ADDENDUM NO. 2

February 9, 2026

Southport High School Addition & Renovation Phase 1 (Activity Center Addition & Wrestling/Center Plant Renovation)
971 E. Banta Road
Indianapolis, IN 46227

PLUMBING ROOF PLAN

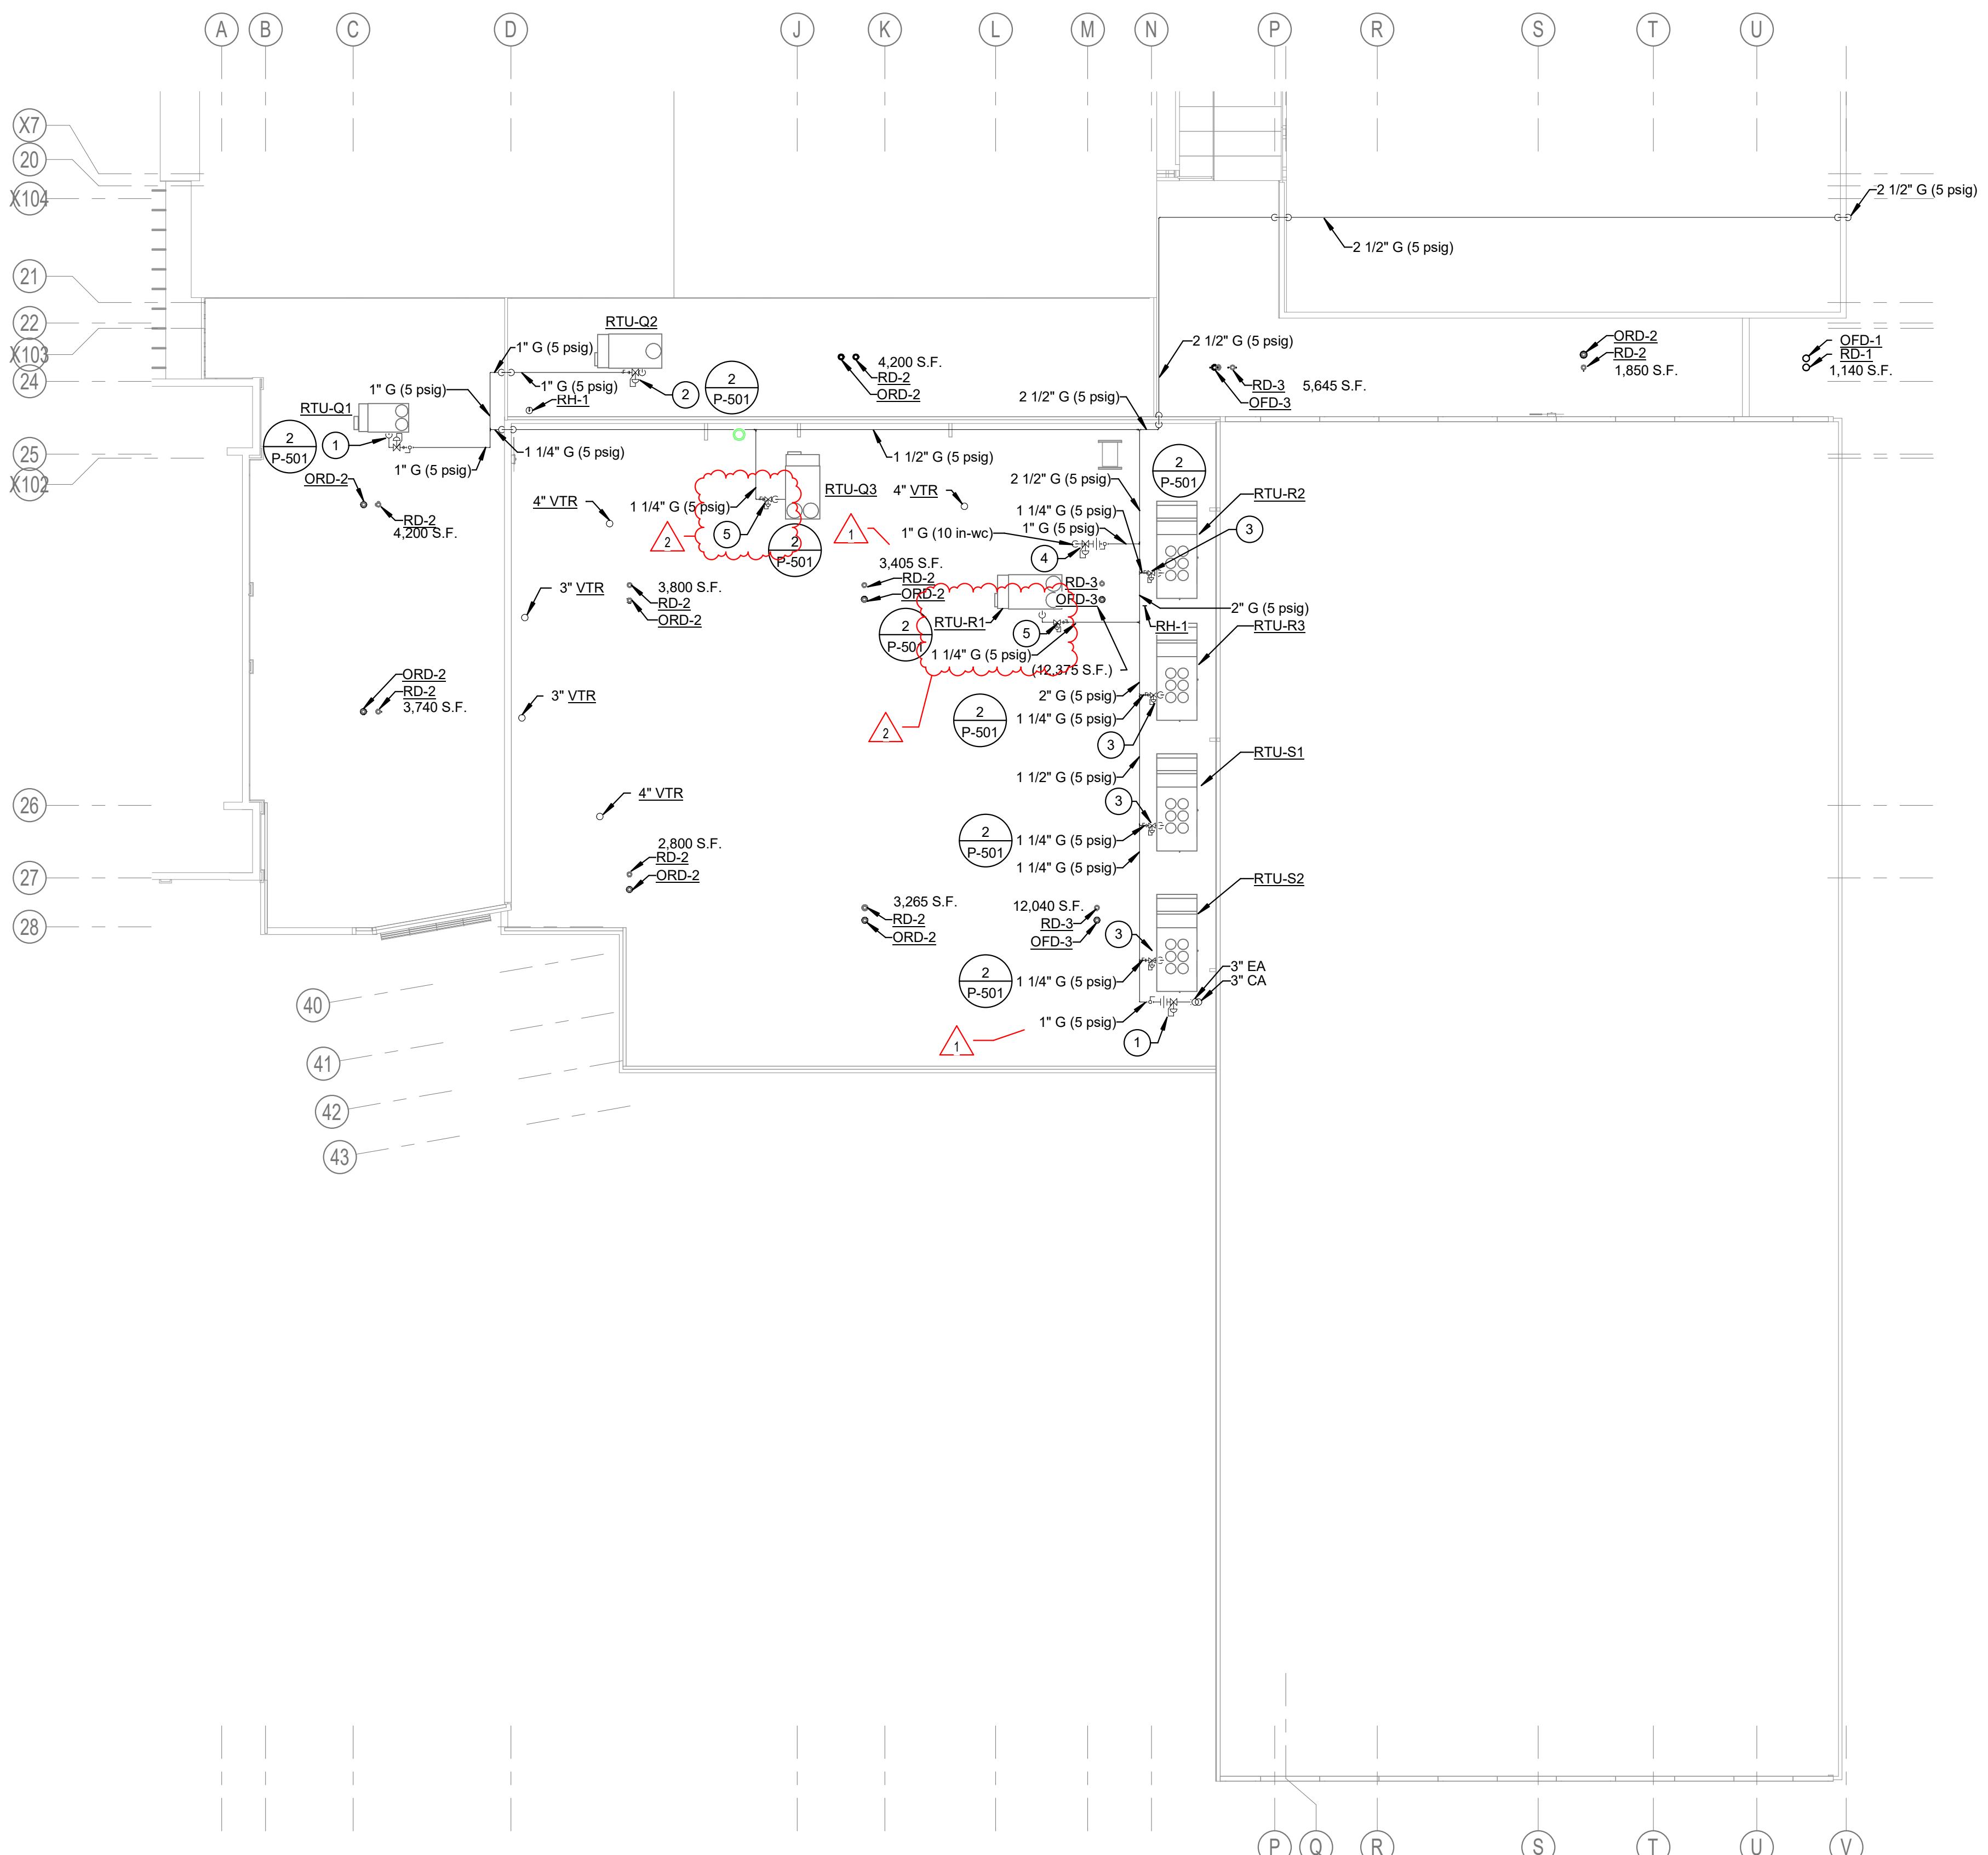
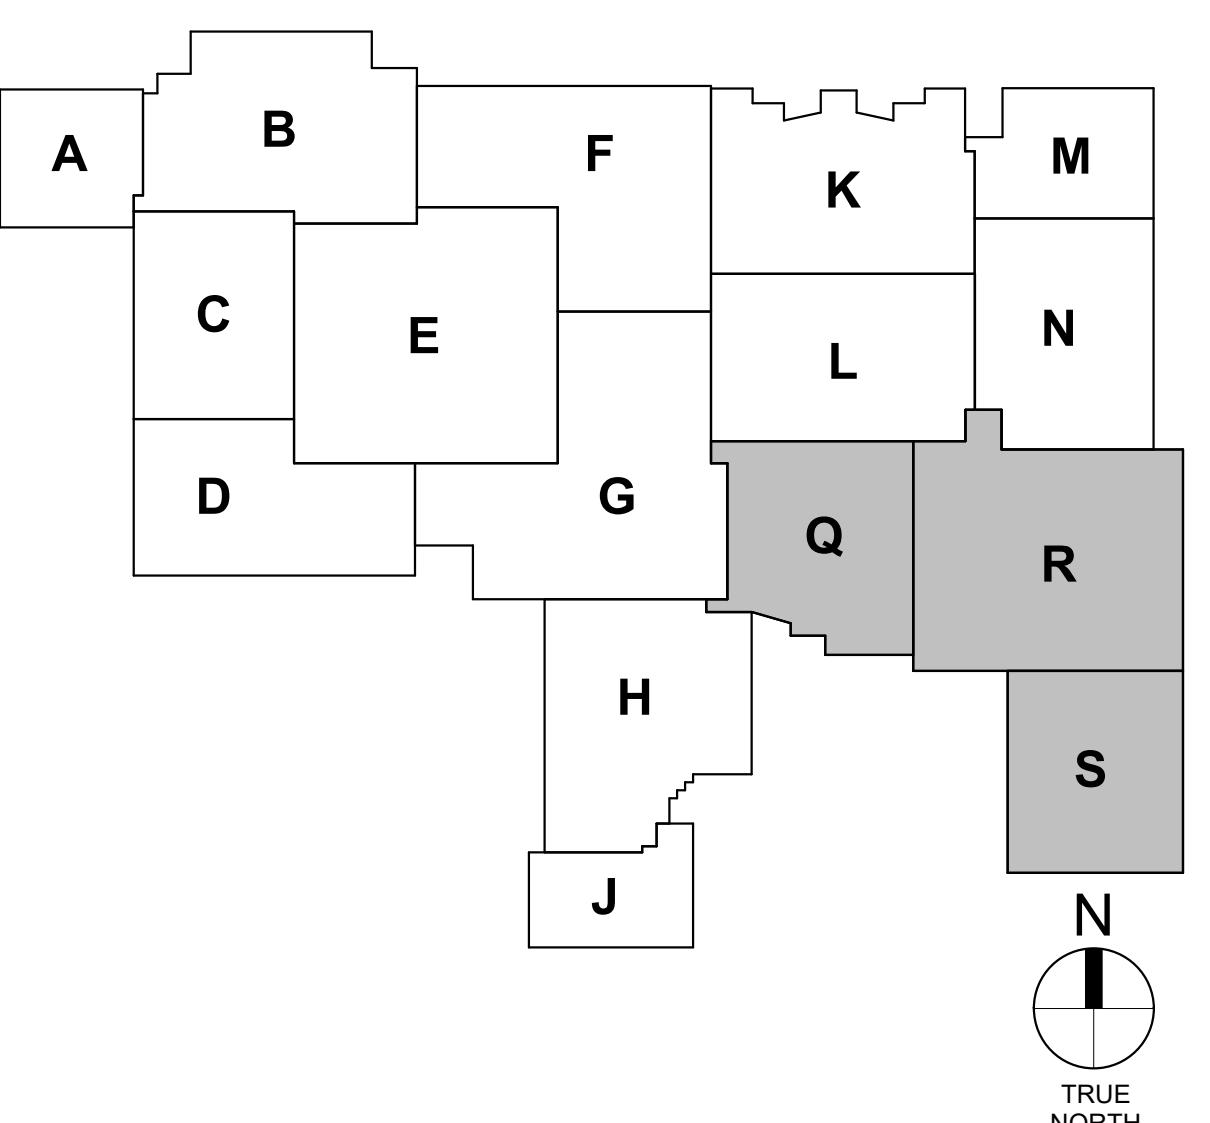
Change: DELETE AND REPLACE Drawing PR101 in its entirety.

1 ELECTRICAL POWER FIRST FLOOR PLAN - UN
1/8" = 1'-0"

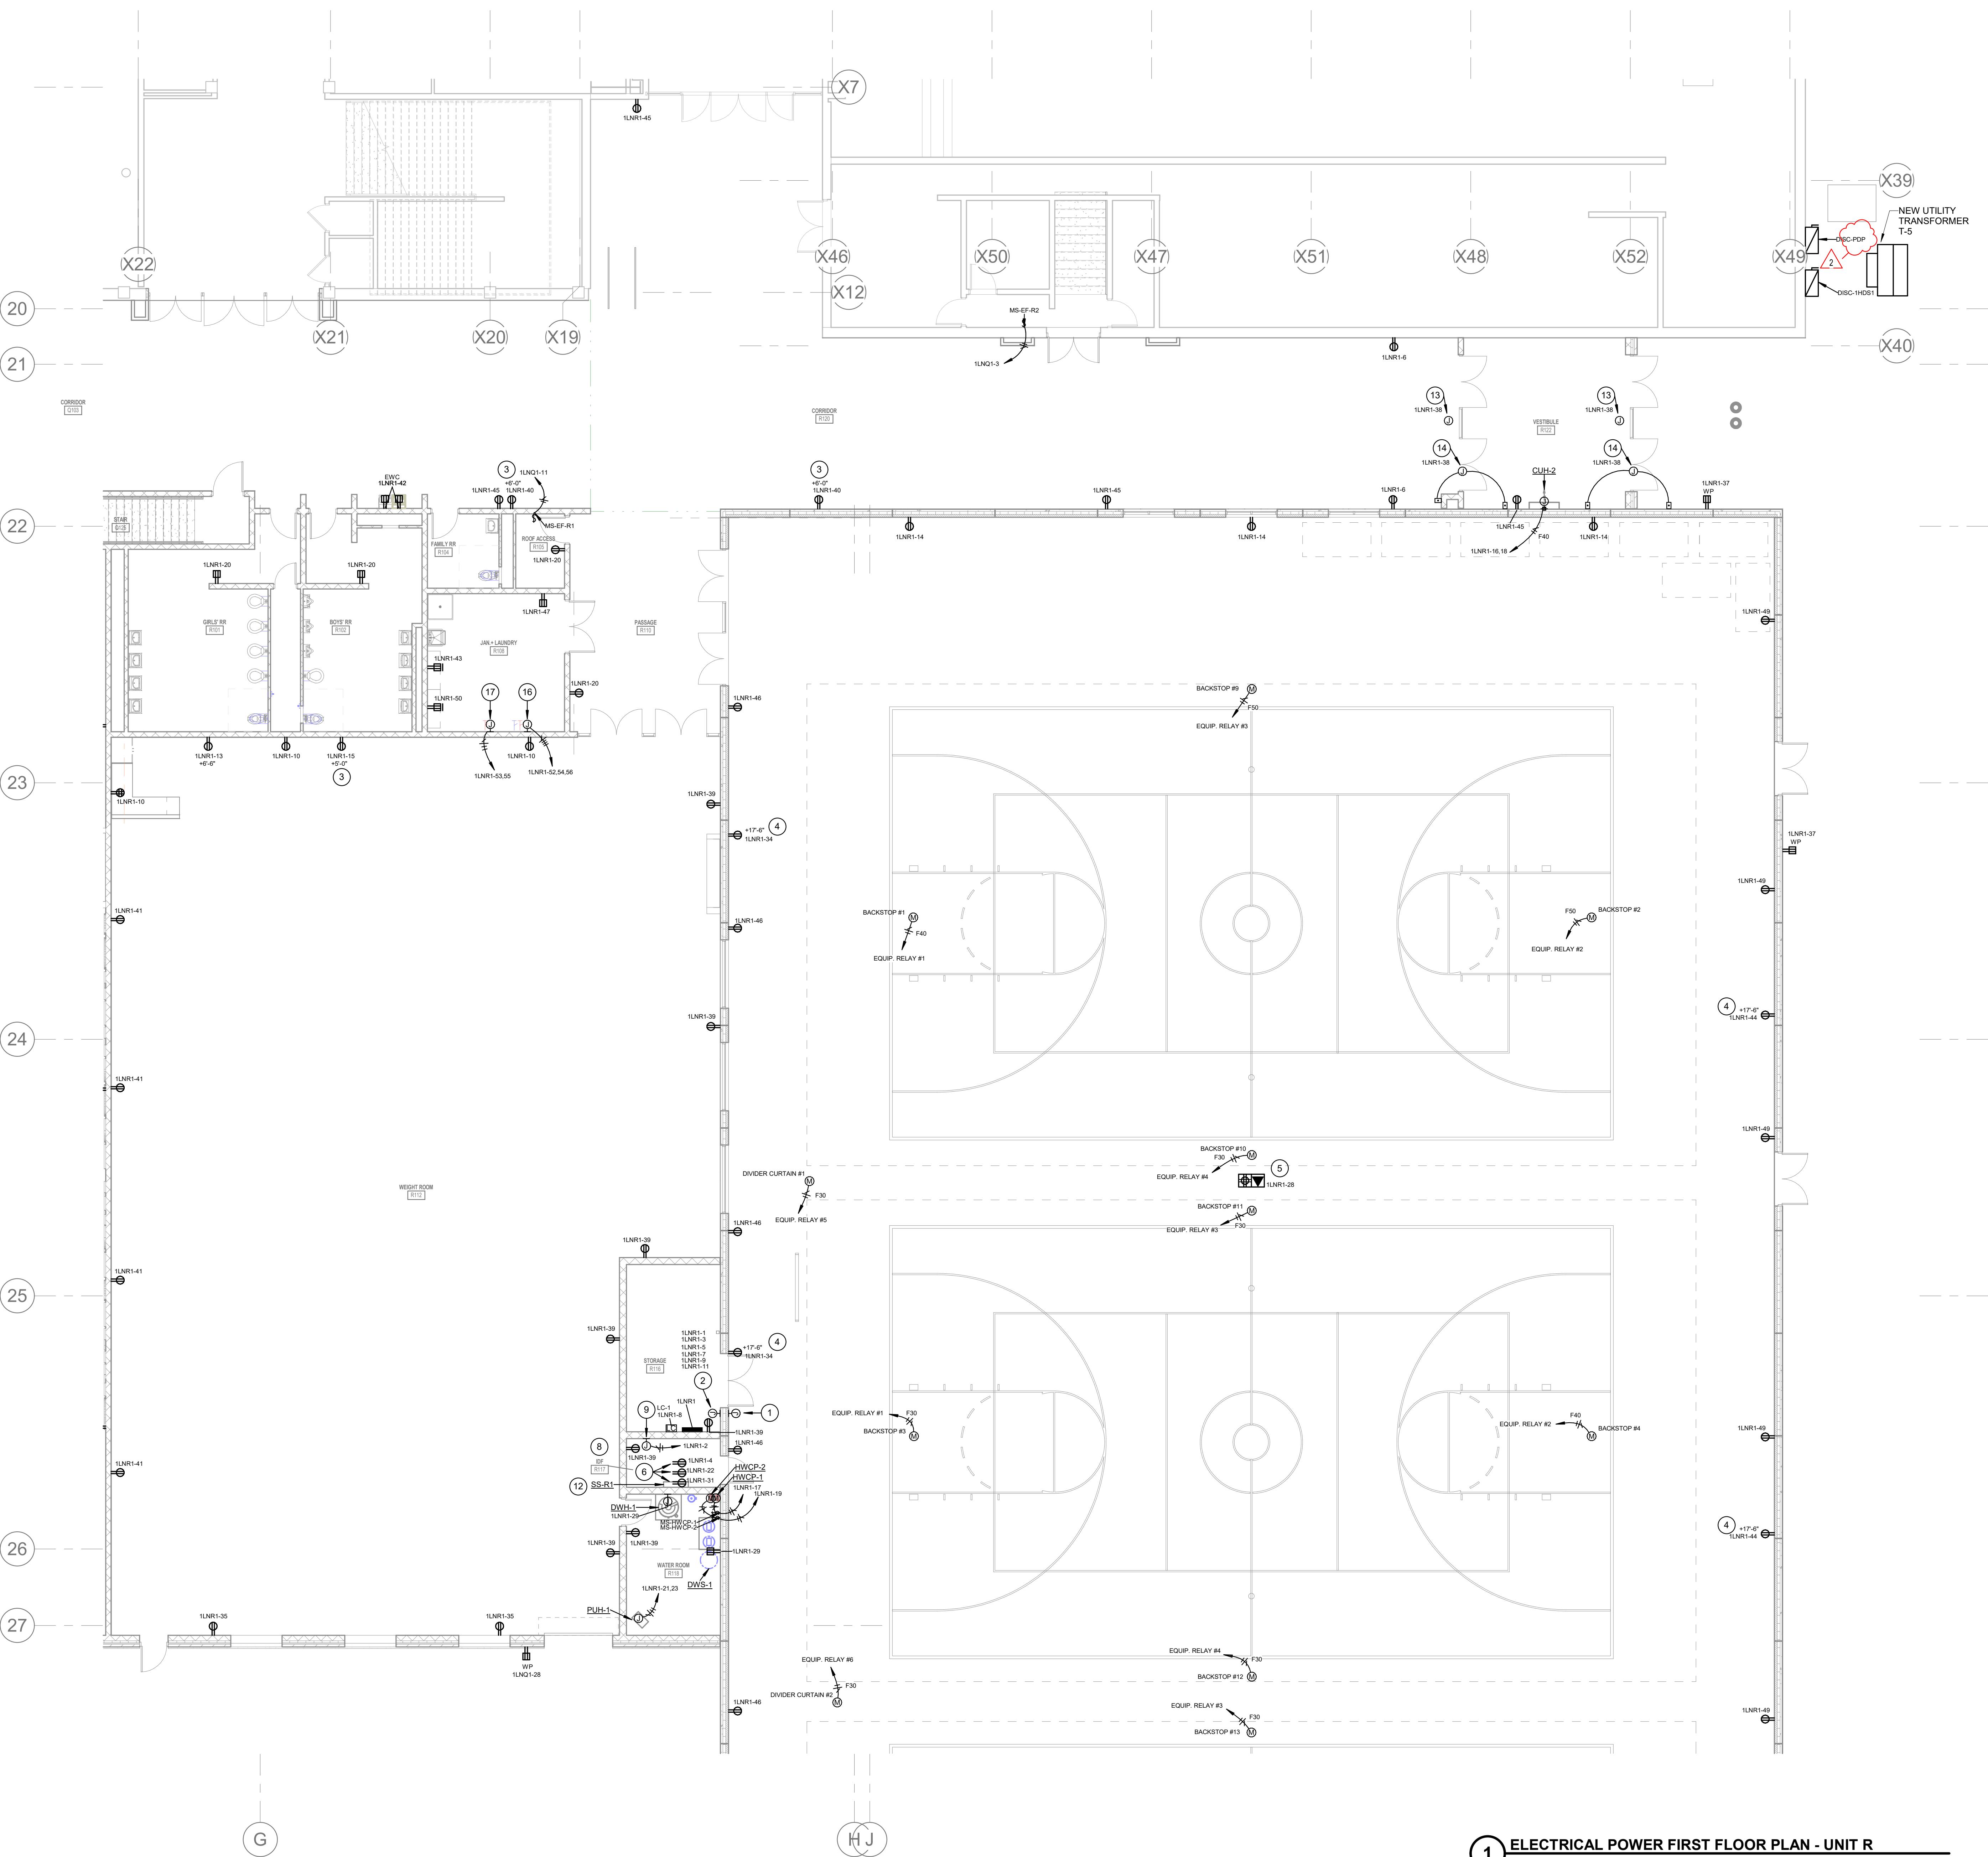
Change: Changed disconnect designation from DISC-PSB to DISC-PDP.
